5443 Ridgedale Scope of Work

DENIED	
DATE	6/1/2026
BY	Marisol Martinez
PHONE	
REASON

1. The application to paint the previously unpainted brick at 5443 Ridgedale is denied.
2. The structure is classified as High Tudor.
3. Painting of unpainted brick does not meet the standards for remodeling of a High Tudor under Ord. 28946(f)(1) and (2), and applicable sections of Ord. 28946(e).

House when we purchased. Only picture we have of the outside.

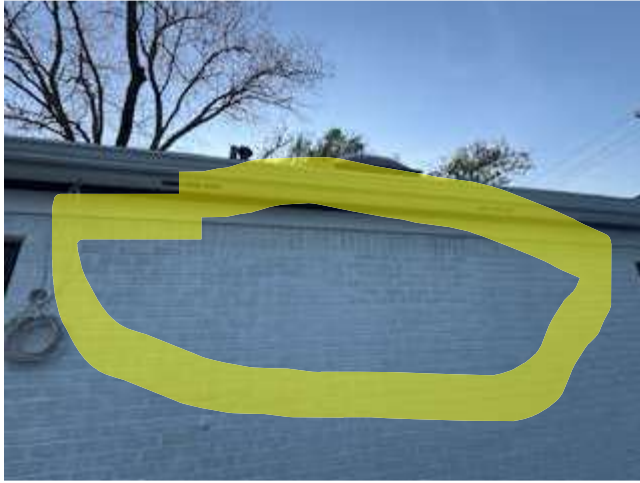
4. Remodeling of houses that are identified as High Tudor or Tudor Cottage in Exhibit B must comply with the standards for new construction and the standards contained in this section. This section applies to the front facade and wrap-around. Ord. 28946(f)(1)

5. Any remodeling must match the original brick and stone in size, color, coursing, texture, mortaring, and joint detailing. Ord. 28946(f)(2)
6. All new construction must be built in the High Tudor style and must be compatible with original houses. Ord. 28946(e)(2)

7. Except as otherwise provided in this paragraph, new houses must be constructed of brick and/or stone using the same colors, course patterns, material placement, and material combinations found in original houses. Ord. 28946(e)(3)(A)

8. Brick must be scratch-face or textured, with at least three subtle variations in tone. Brick colors and textures must be typical of the brick used on original houses. Brick must be modular or standard size. Ord. 28946(e)(3)(B)

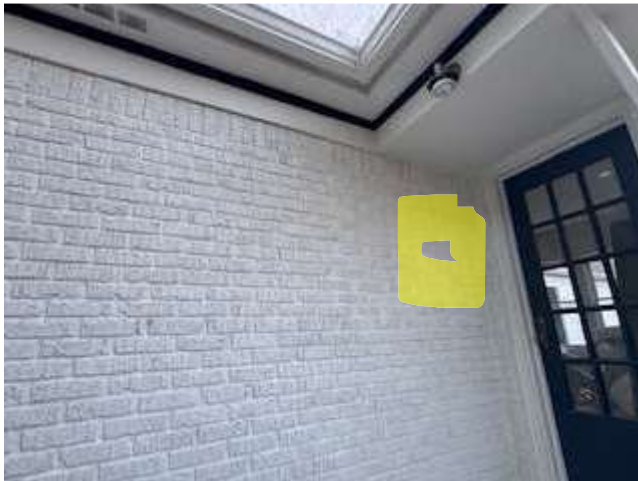
1. The application to paint the previously unpainted brick at 5443 Ridgedale is denied.
2. The structure is classified as High Tudor.
3. Painting of unpainted brick does not meet the standards for remodeling of a High Tudor under Ord. 28946(f)(1) and (2), and applicable sections of Ord. 28946(e).

4. Remodeling of houses that are identified as High Tudor or Tudor Cottage in Exhibit B must comply with the standards for new construction and the standards contained in this section. This section applies to the front facade and wrap-around. Ord. 28946(f)(1)

5. Any remodeling must match the original brick and stone in size, color, coursing, texture, mortaring, and joint detailing. Ord. 28946(f)(2)
6. All new construction must be built in the High Tudor style and must be compatible with original houses. Ord. 28946(e)(2)

7. Except as otherwise provided in this paragraph, new houses must be constructed of brick and/or stone using the same colors, course patterns, material placement, and material combinations found in original houses. Ord. 28946(e)(3)(A)

8. Brick must be scratch-face or textured, with at least three subtle variations in tone. Brick colors and textures must be typical of the brick used on original houses. Brick must be modular or standard size. Ord. 28946(e)(3)(B)
